Project: Fraser House	Eng: MWS
Title: Third floor structure	Date: May'23
No: LM21346-DYSE-XX-ZZ-SK-S-0025	Rev: P03

Third Floor Structure Indicating Fourth Floor Structure Over

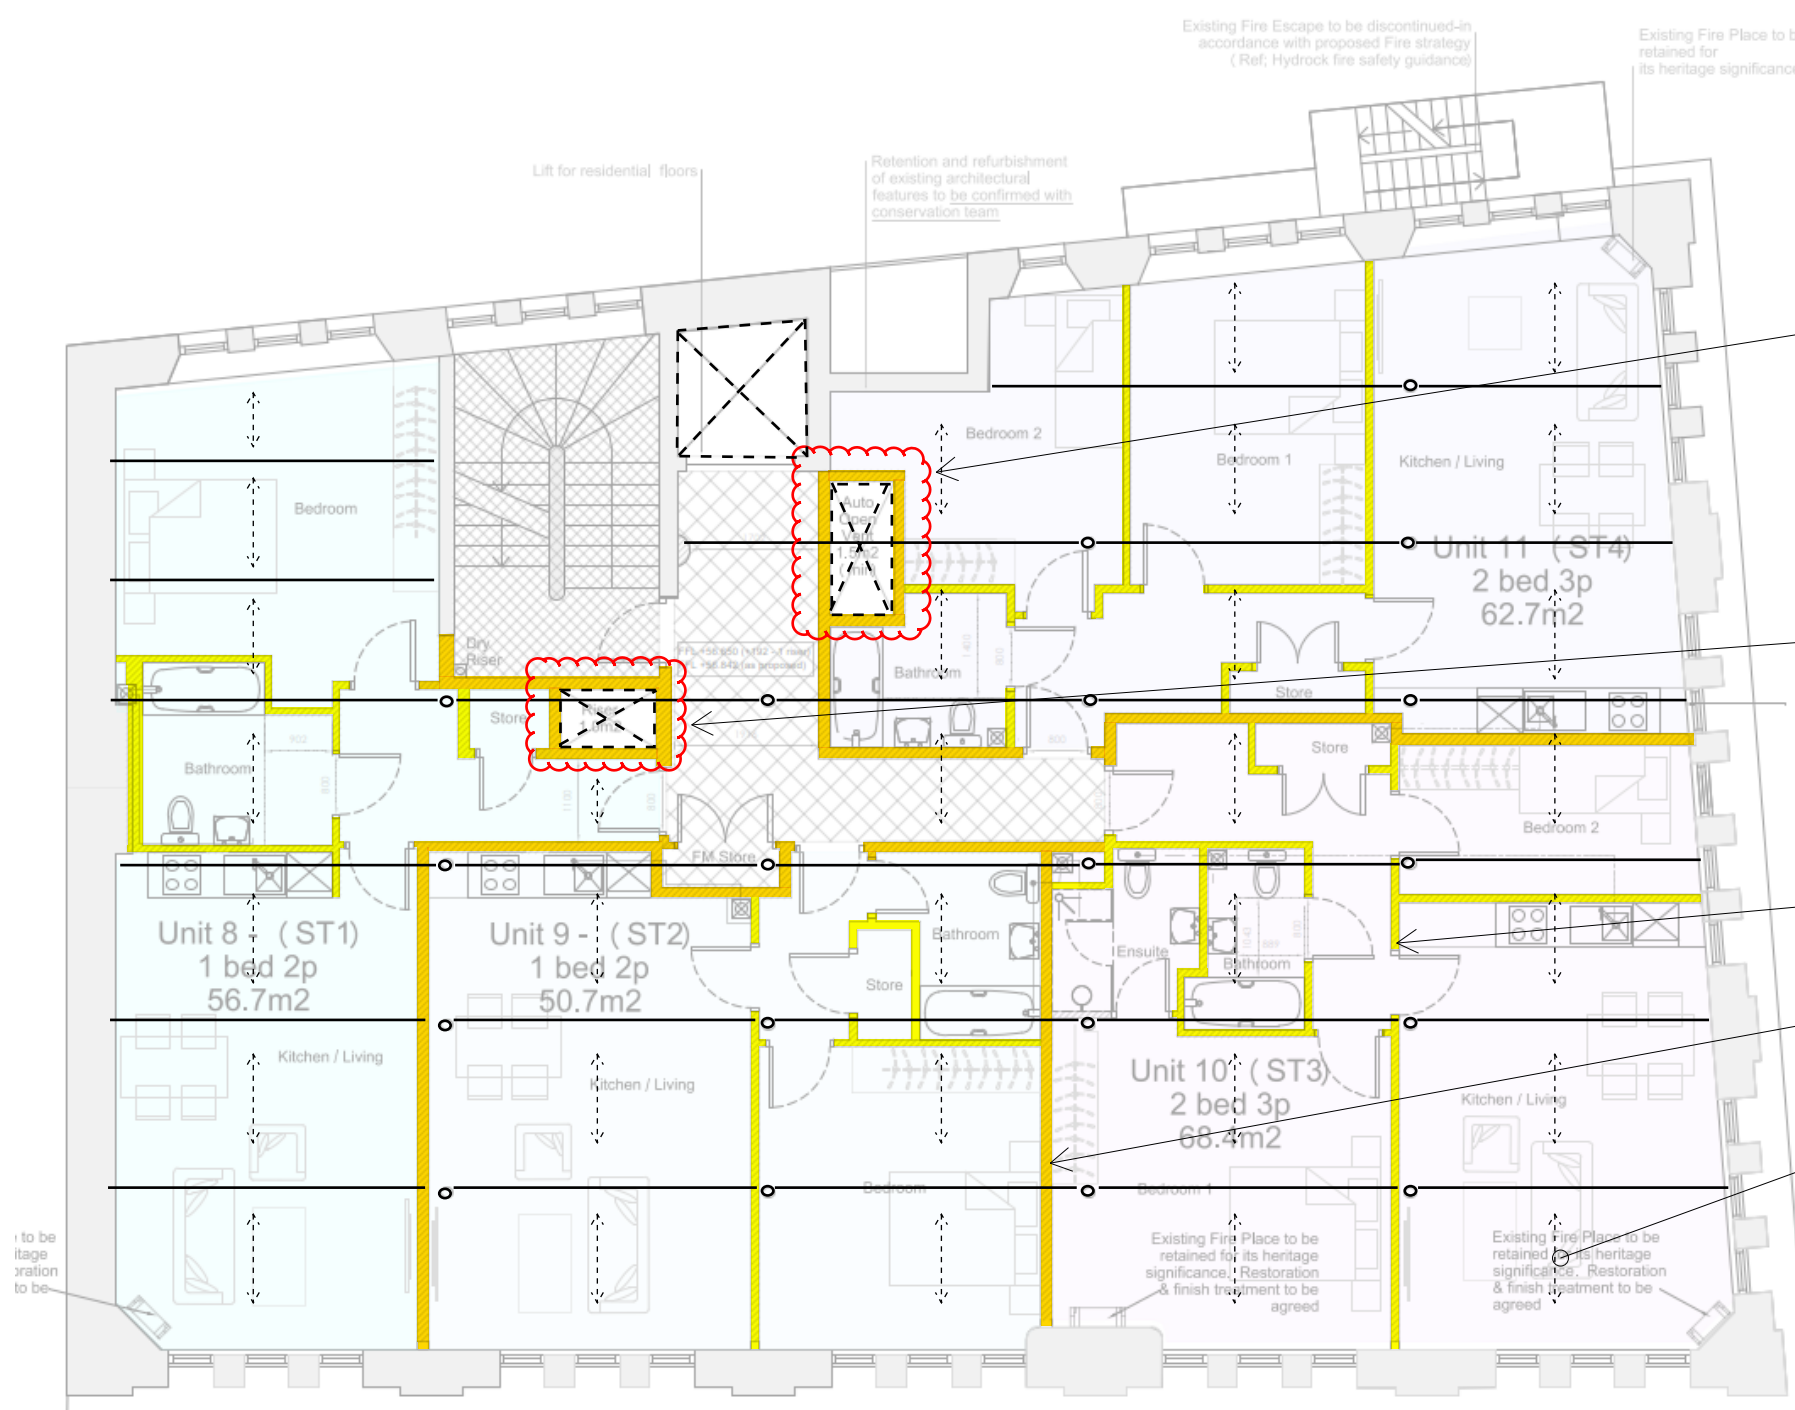
Location of smoke vent cuts through existing primary timber floor beam. Can smoke vent be moved to avoid additional significant structural framing to trim out void for smoke vent. Architects to confirm acceptance.

Location of service riser cuts through existing primary timber floor beam. Can beam continue to pass through service riser to avoid additional significant structural framing to trim out void for smoke vent. Architects & M&E consultants to confirm acceptance.
